**| Braidwood Units 1 and 2 – Responses to NRC Request for Additional Information (RAI) Regarding
Ultimate Heat Sink Temperature Increase License Amendment Request
(License Nos. NPF-72 and NPF-77)**

April 2015

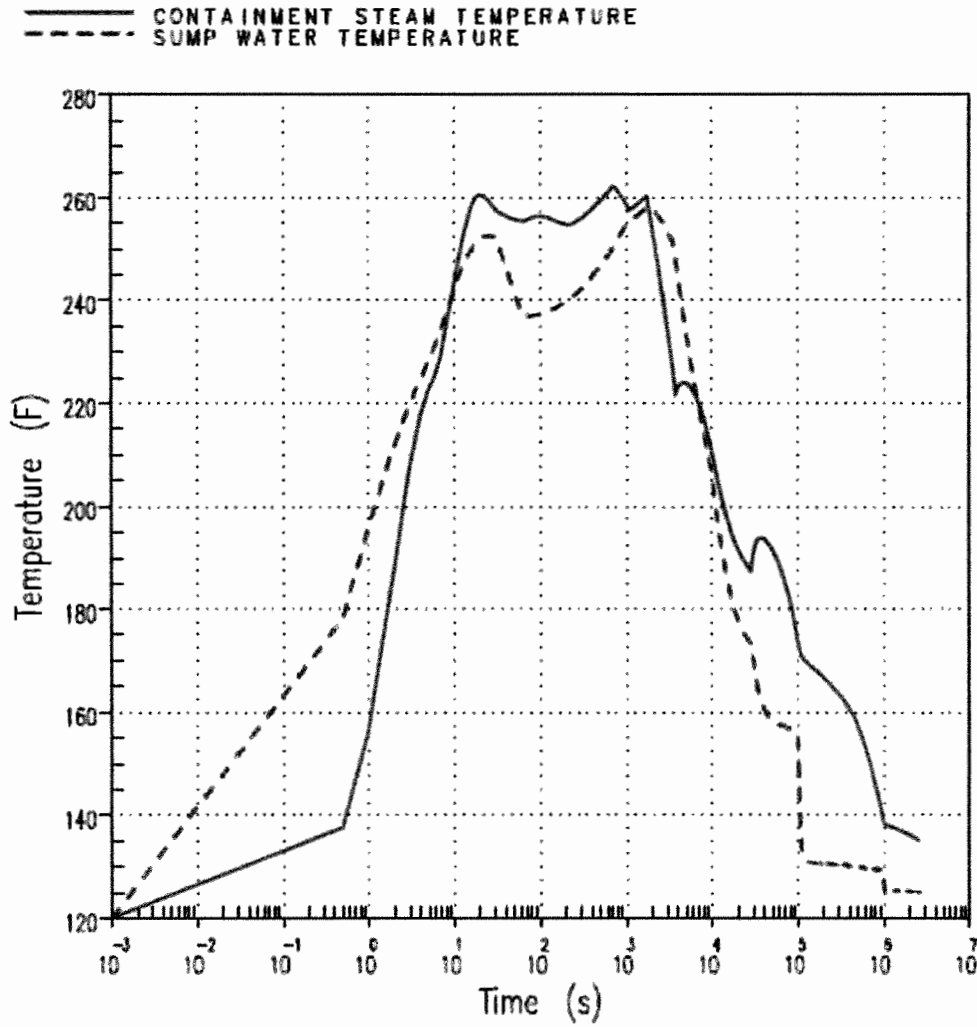
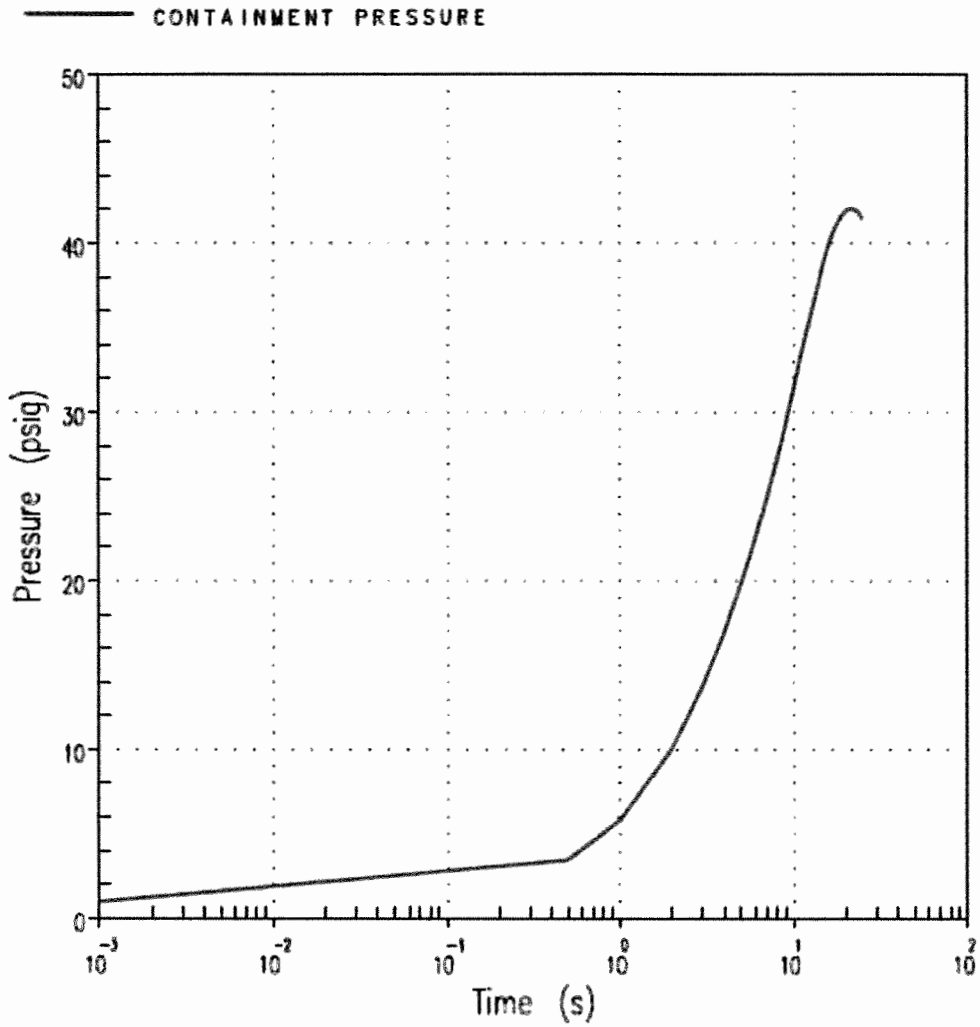
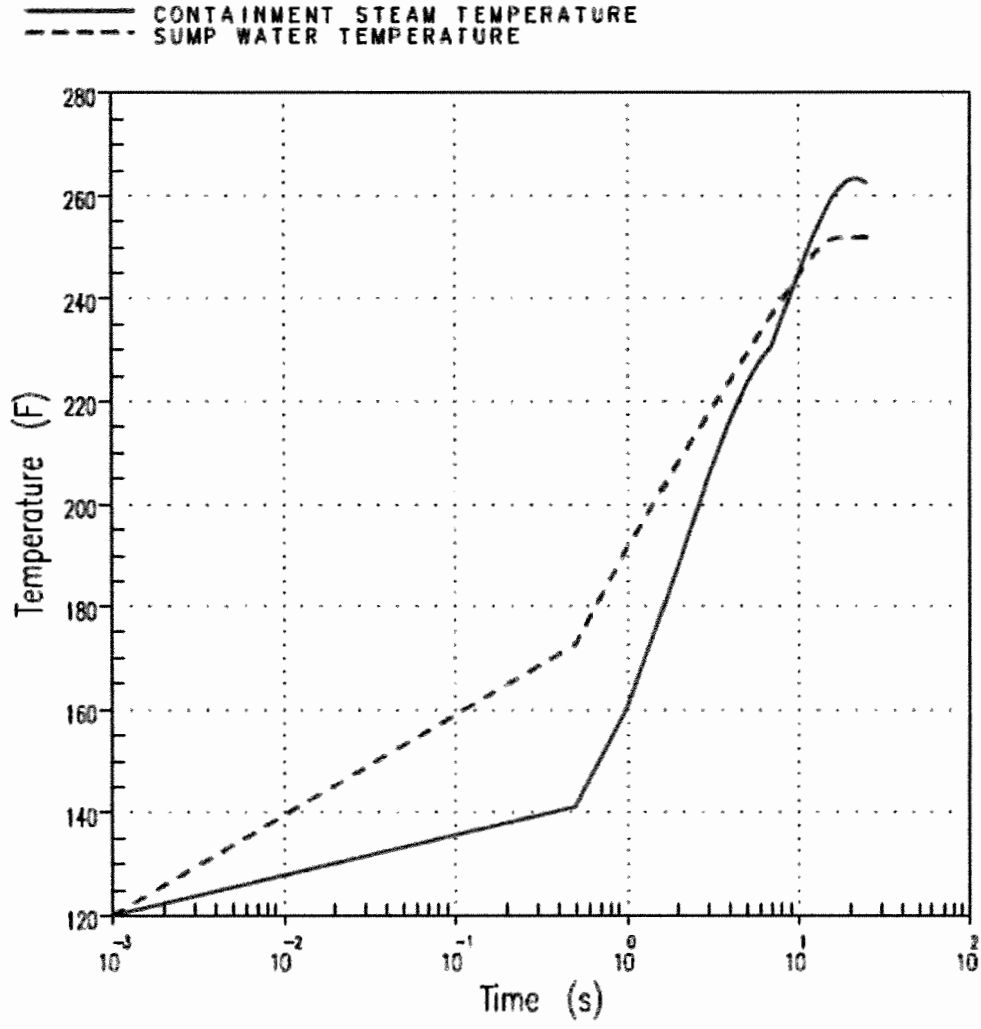
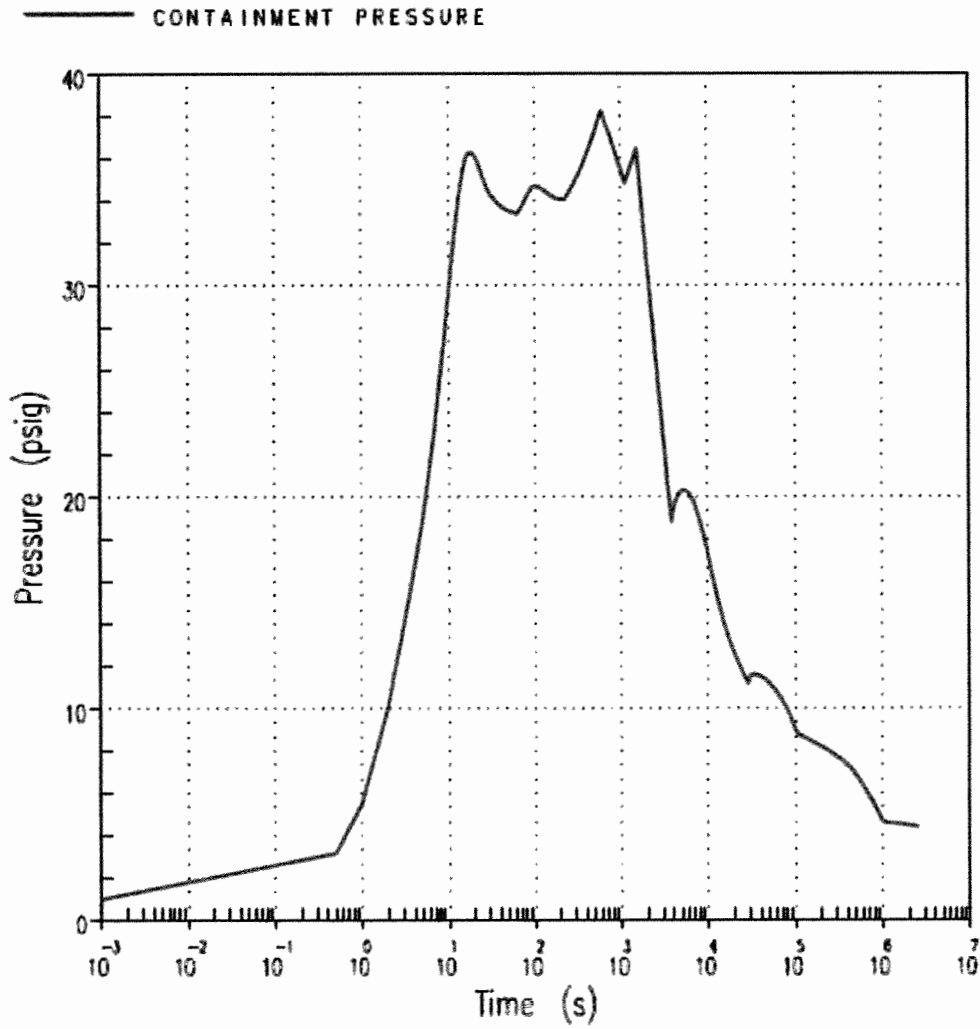
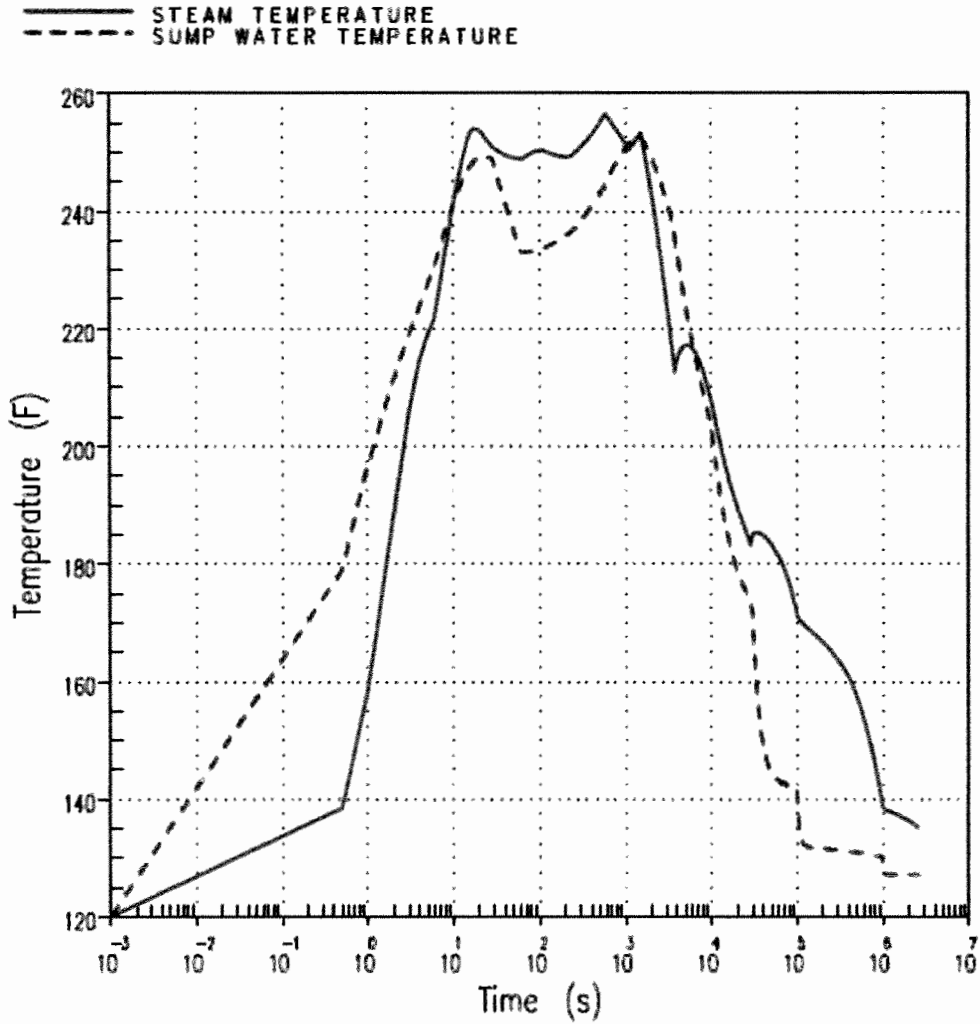
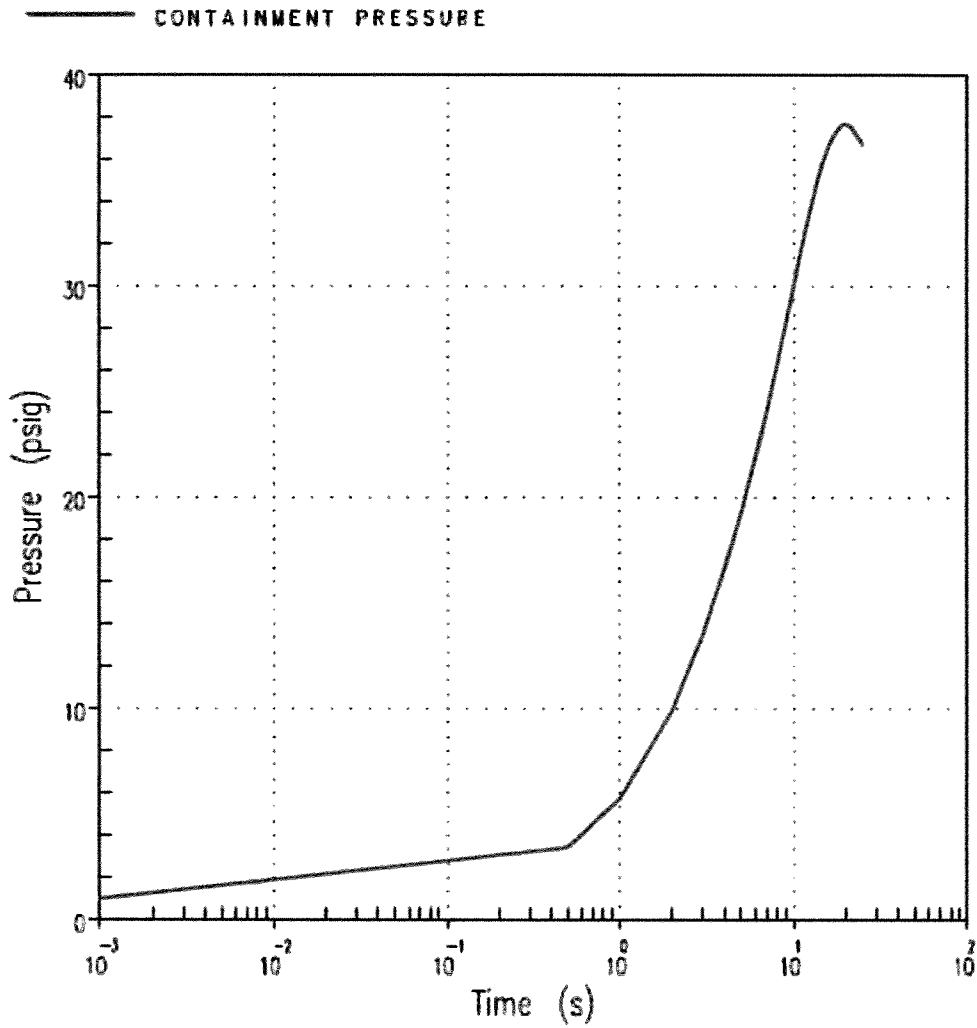
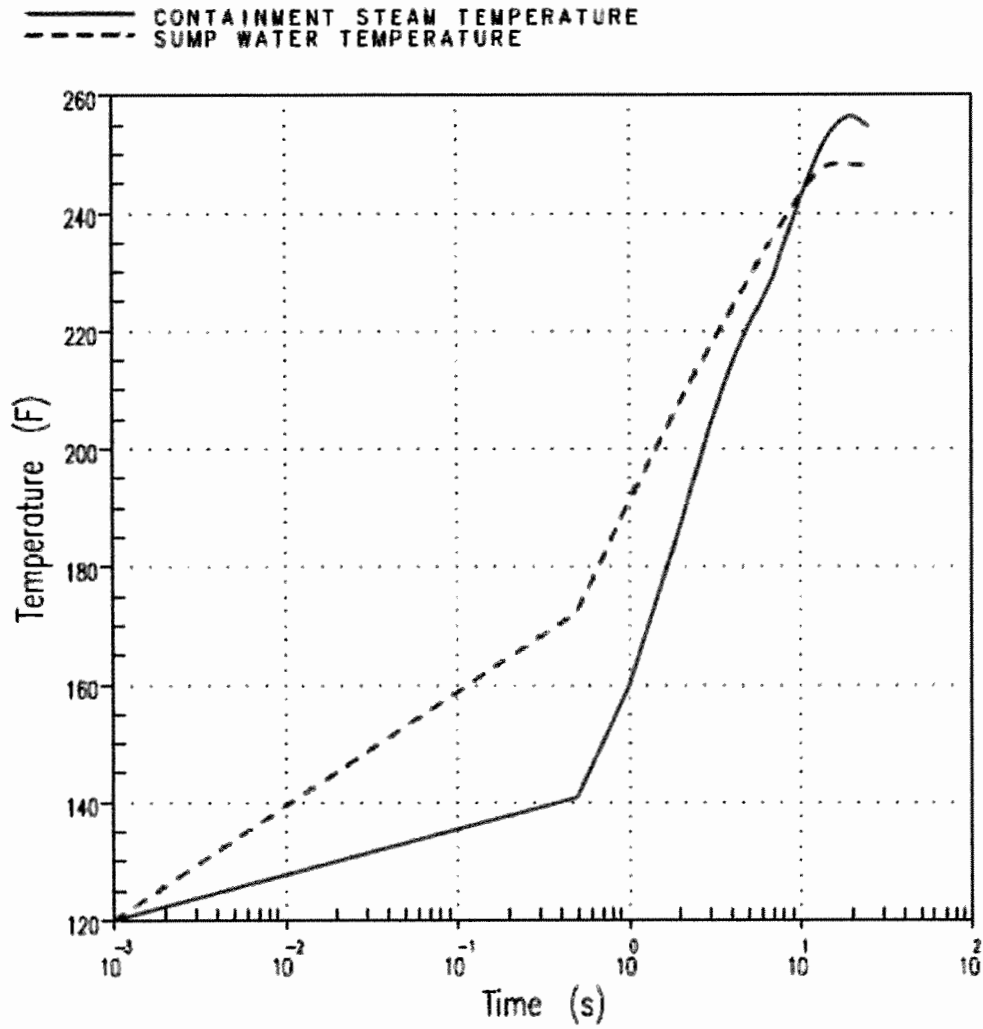
- (d) Provide the resulting graphs for the most limiting LOCA peak pressure analysis for the double ended hot leg break and double ended pump suction break for both units.*

Westinghouse Response – Item (d)

SCVB-RAI-6 – Figure 1: Units 1

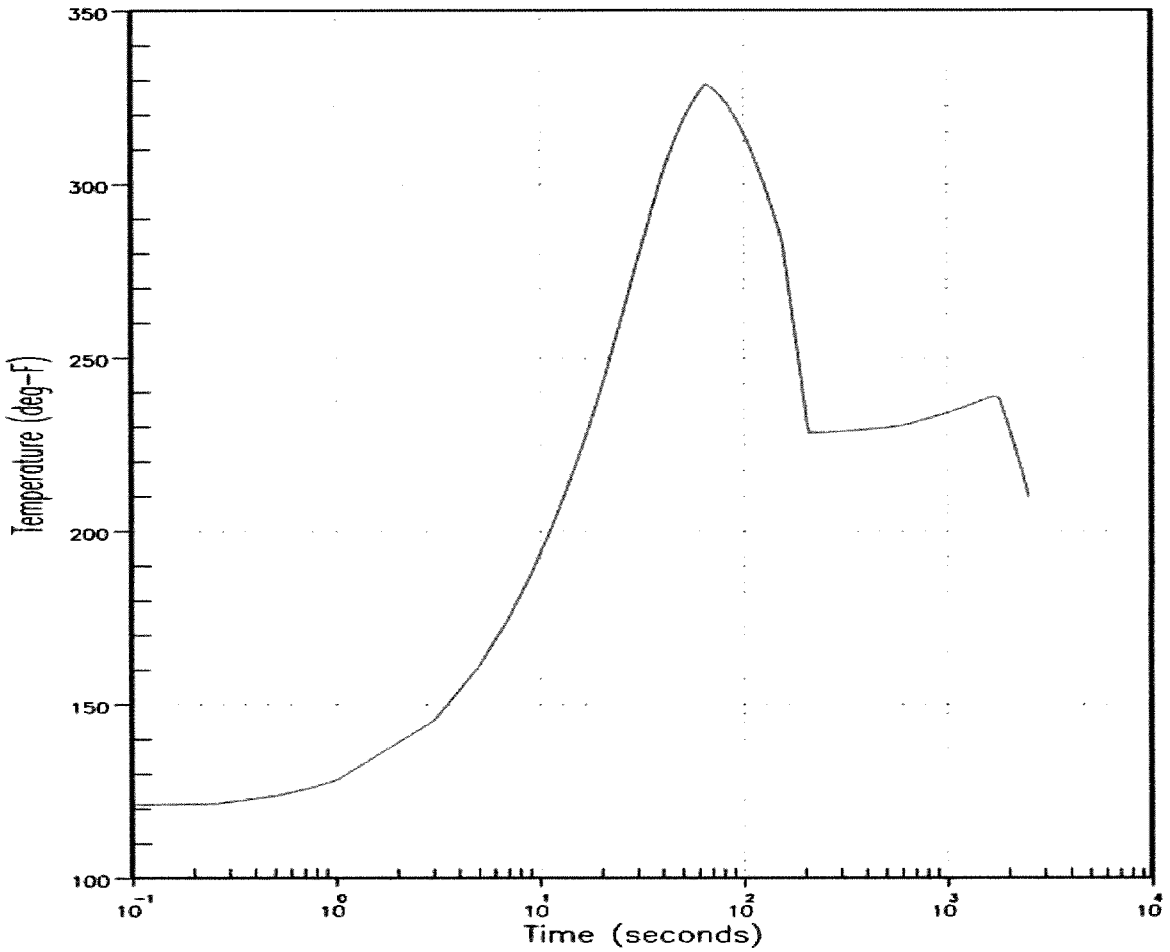
- (a) Describe the MSLB cases analyzed for containment peak temperature, and provide their comparison with the cases analyzed in the current analysis.*
- (b) If other than the currently analyzed cases were selected, provide basis for their selection.*
- (c) Provide a comparison of the inputs and assumptions in the proposed analysis that were changed from the current analysis. Provide justification for those inputs and assumptions in which the conservatism in the proposed analysis is reduced.*
- (d) Explain why the peak containment temperatures are less in the proposed analysis than in the current analysis.*
- (e) Provide the graph of the most limiting MSLB peak temperature profile case.*

Westinghouse Response – SCVB-RAI-6 – Item (e)

Containment Temperature for SLB
Unit 1 Most Limiting SLB Case

SCVB-RAI-7 – Figure 1: Units 1

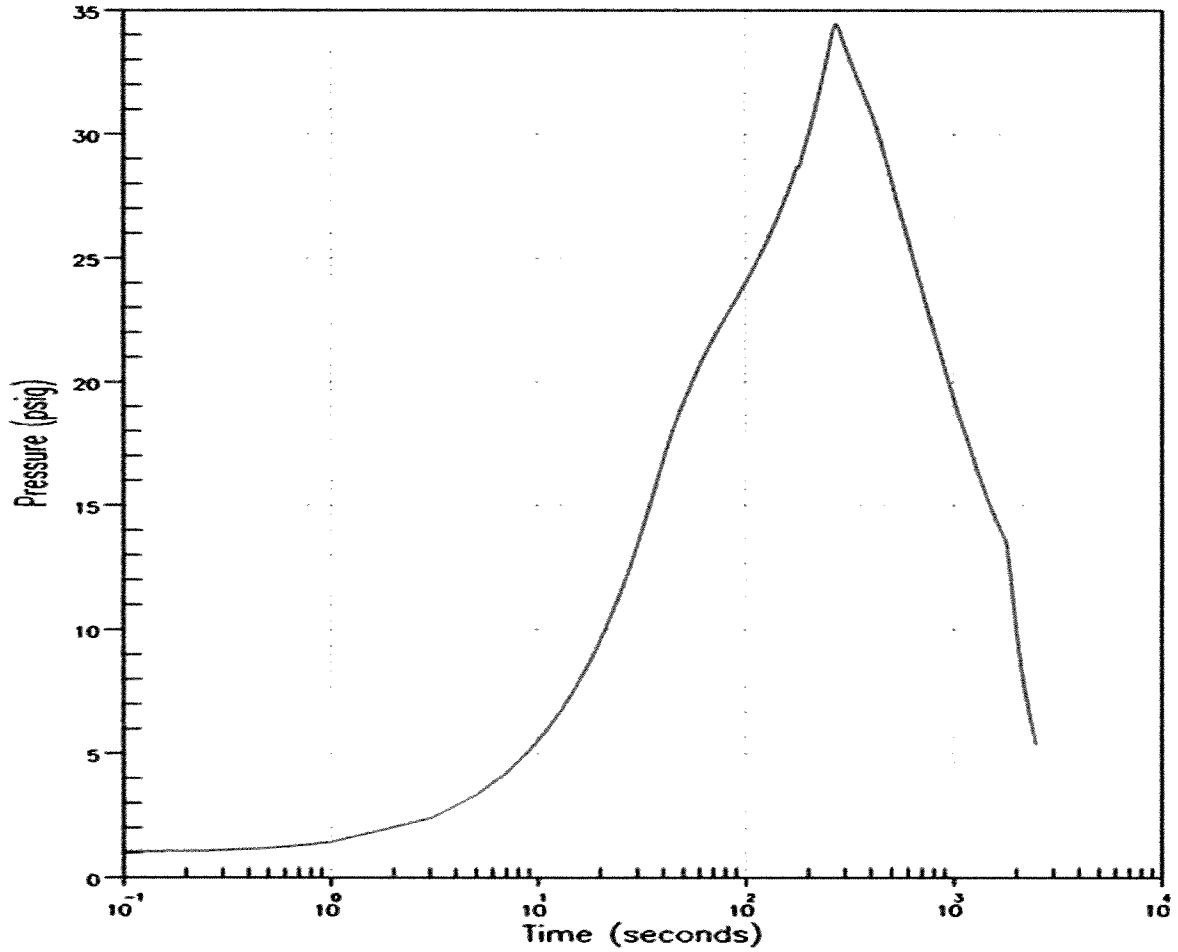
- (a) Describe the MSLB cases analyzed for containment peak pressure, and provide their comparison with the cases analyzed in the current analysis.*
- (b) Describe the cases in the proposed and the current analysis that resulted in the maximum peak pressures.*
- (c) If other than the currently analyzed cases were selected, provide basis for their selection.*
- (d) Provide a comparison of the inputs and assumptions in the proposed analysis that were changed from the current analysis. Provide justification for those inputs and assumptions in which the conservatism in the proposed analysis is reduced.*
- (e) Provide the graph of the most limiting MSLB peak pressure profile case.*

Containment Pressure for SLB
Unit 1 Most Limiting SLB Case
